**REPORT TO THE SUBDIVISION AND  
DEVELOPMENT APPEAL BOARD**

| <b>DATE:</b> August 25, 2026                                                                                                                                                                                                                                                                                                | <b>APPEAL NO.:</b> SDAB2026-0125<br><b>FILE NO.:</b> DP2025-06578 |
| <b>FROM A DECISION OF THE DEVELOPMENT<br/>AUTHORITY where a</b><br><br><b>New: Rowhouse Building (1 building),<br/>Accessory Residential Building (garage and<br/>mobility storage), Secondary Suite (4 suites)</b><br><br><b>was approved at <u>10 Cheyenne Crescent NW</u><br/><u>(Bldg: 4 Cheyenne Crescent NW).</u></b> | <b>LAND USE DESIGNATION: R-CG</b><br><br><b>Discretionary</b>     |

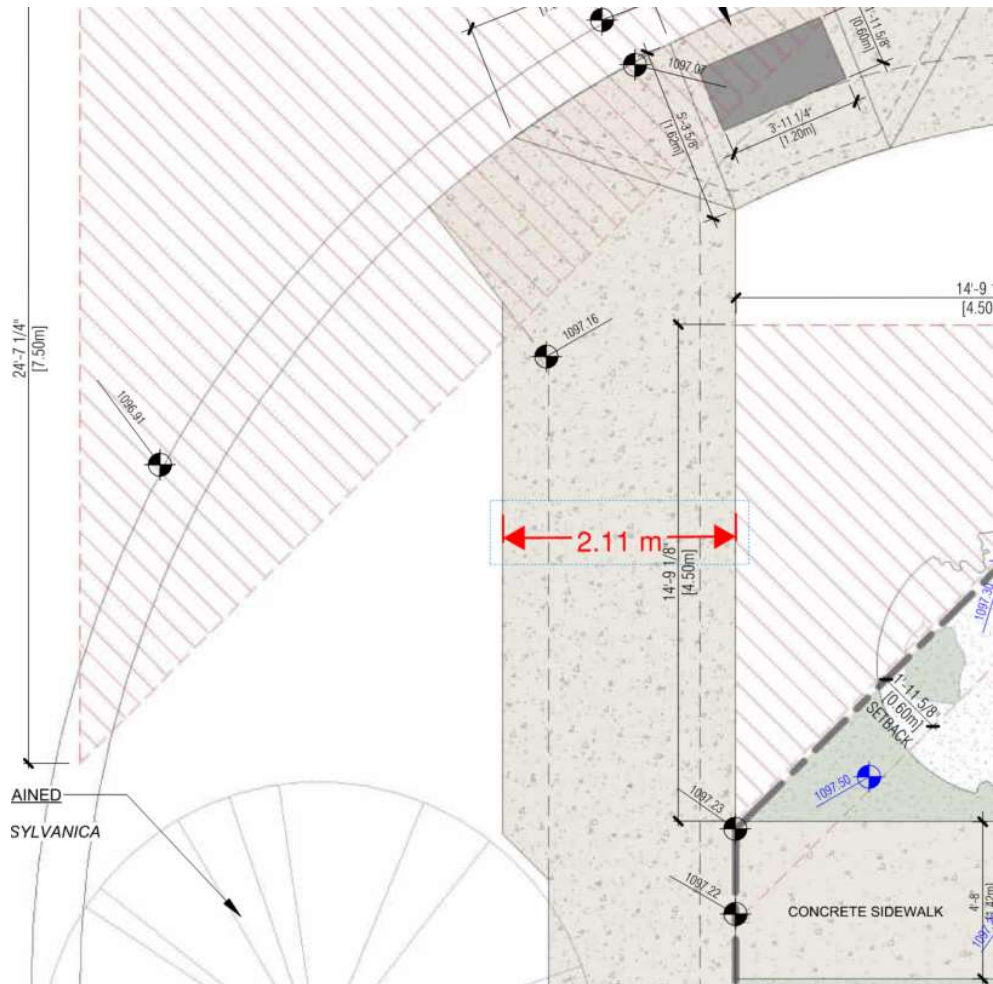
Please amend the plans to revise the width of the proposed widened sidewalk along Northmount Drive NW from 2.11m to 2.0m.

Also, as outlined in the initial review, please extend the sidewalk replacements across any adjacent lanes (driveway crossing for lane access).

Amend the plans to revise the width of the separate sidewalk segment located nearest the wheelchair ramp (as shown in the image) from 2.11m to 2.0m.

Please note the reconstruction of the existing driveway crossing (access to the lane) to accommodate the new proposed sidewalk widening on Cheyenne Crescent NW is to be designed in accordance with Roads Specification 454.1010.003. Please revise the note on the site plan accordingly.

**1 SITE PLAN**  
1:60

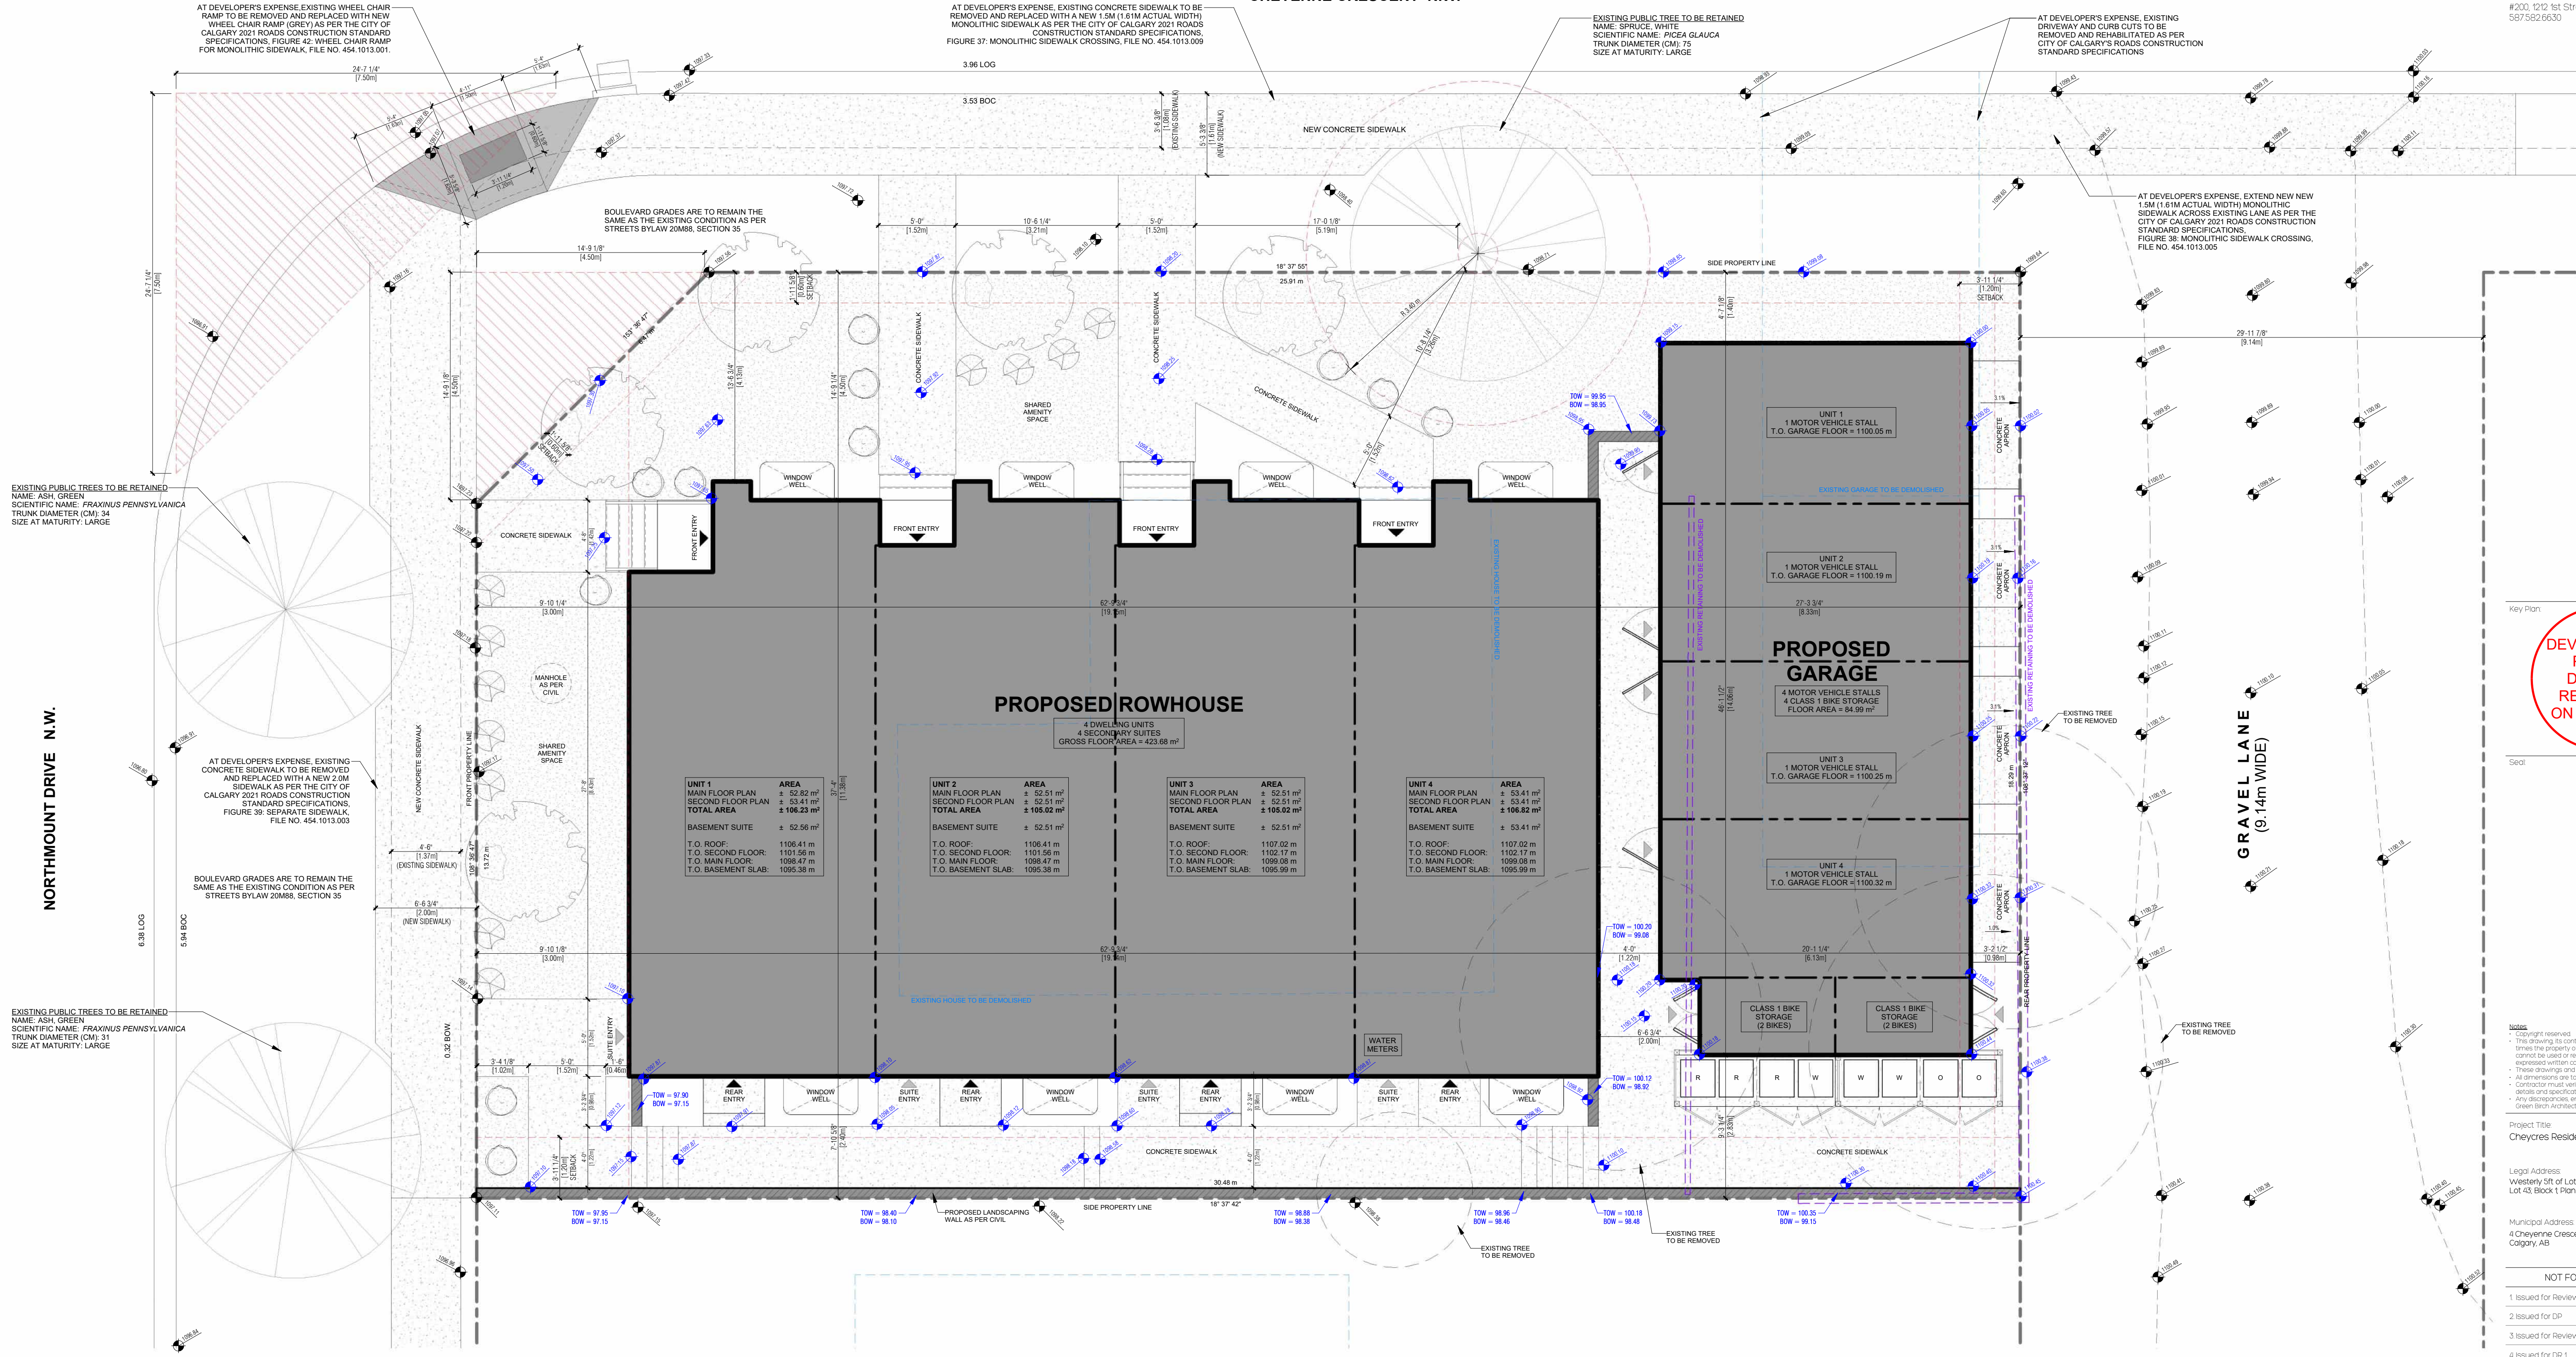
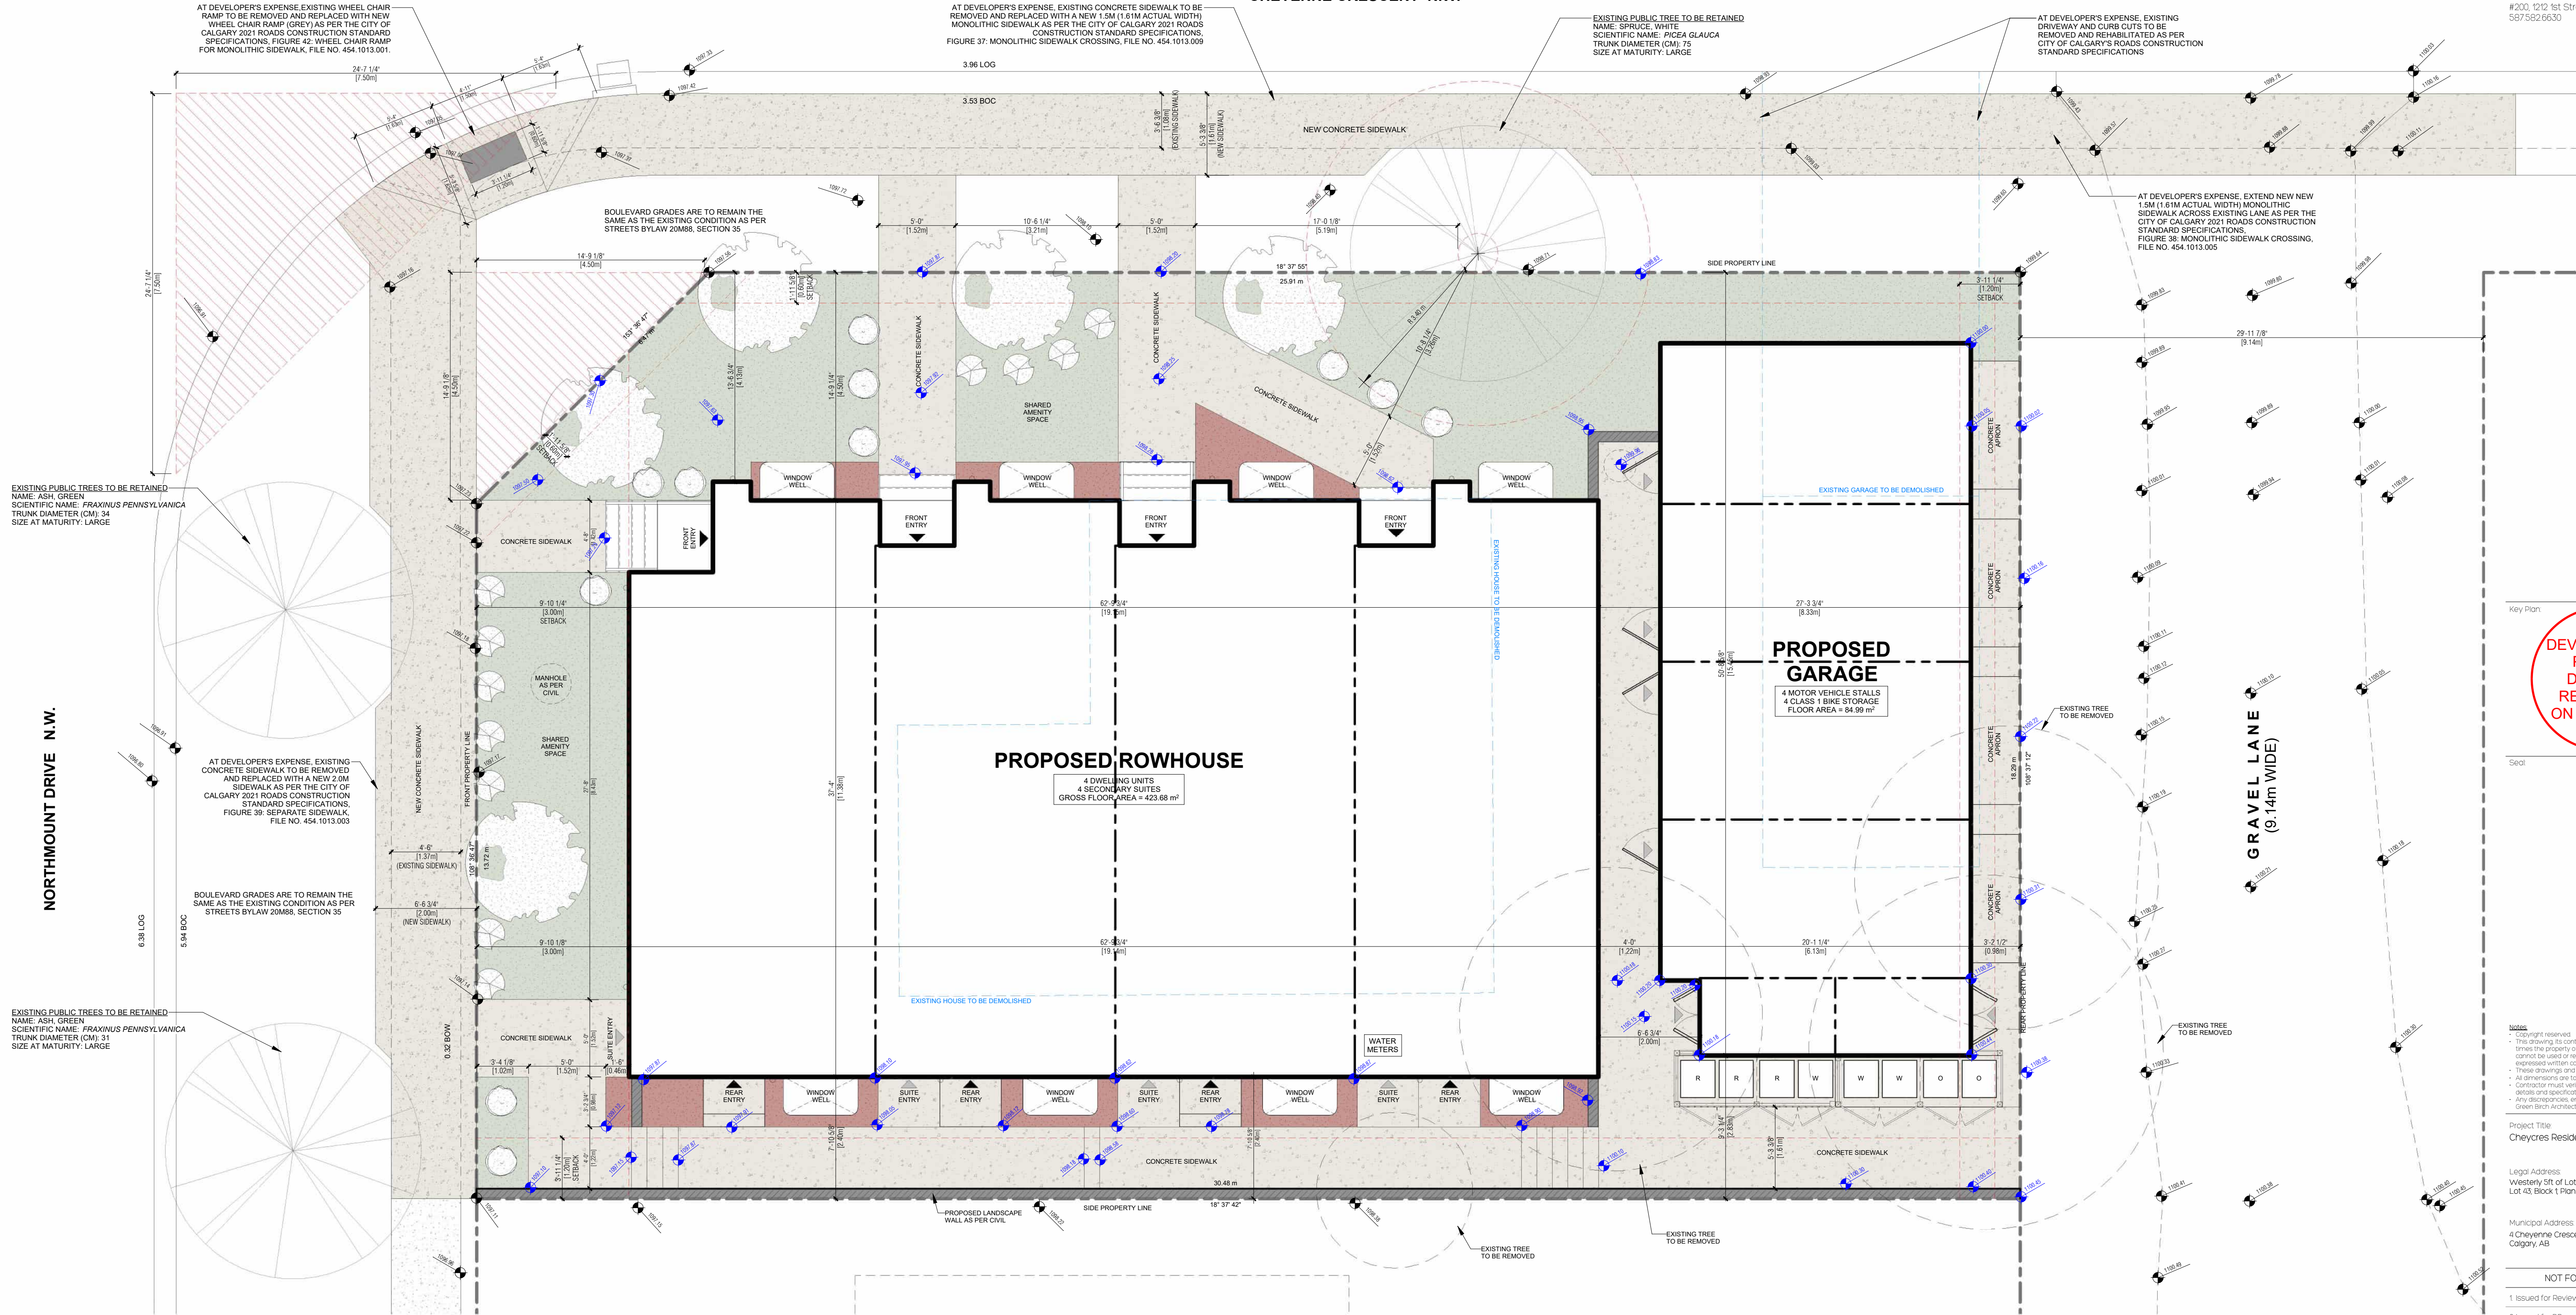
Based on my understanding of the plans, the proposed structure has a setback of only approximately 1.2 metres from the sidewalk along Northmount Drive. This is unacceptable. From my living room and bedroom windows, I will be looking directly at a large, imposing structure at extremely close proximity.

The plans indicate space for eight waste bins. However, eight dwelling units requiring garbage, recycling, and compost bins would reasonably require approximately 24 bins. Additionally, the garage structure appears to occupy most of the alley space. It is unclear where bins will be placed on collection days, and there is a strong likelihood they will encroach onto my property, which is unacceptable.

| Final Bylaw Relaxations                       |                                                                                                                                                                                                                                                             |                                                                                                                          |
|-----------------------------------------------|-------------------------------------------------------------------------------------------------------------------------------------------------------------------------------------------------------------------------------------------------------------|--------------------------------------------------------------------------------------------------------------------------|
| 537 Building Setback from Front Property line | The minimum building setback from a front property line is 3.0m                                                                                                                                                                                             | Plans indicate the setback from the South property line is 1.20m (-1.80m).<br><br><b>Resolved.</b>                       |
| 336 Projections Into Front Setback Area       | (1) Unless otherwise referenced in subsection (6), bay windows and eaves may project a max. of 0.6 m into the front setback area.                                                                                                                           | Plans indicate the South building eaves project 2.05m (+1.45m) within the front setback area.<br><br><b>Resolved.</b>    |
| 539 Building Setback from Side Property Line  | (6) For a corner parcel, the minimum building setback from a side property line shared with a street is 0.6m                                                                                                                                                | Plans indicate the setback from the West property line is 0.41m (-0.19m).<br><br><b>Resolved.</b>                        |
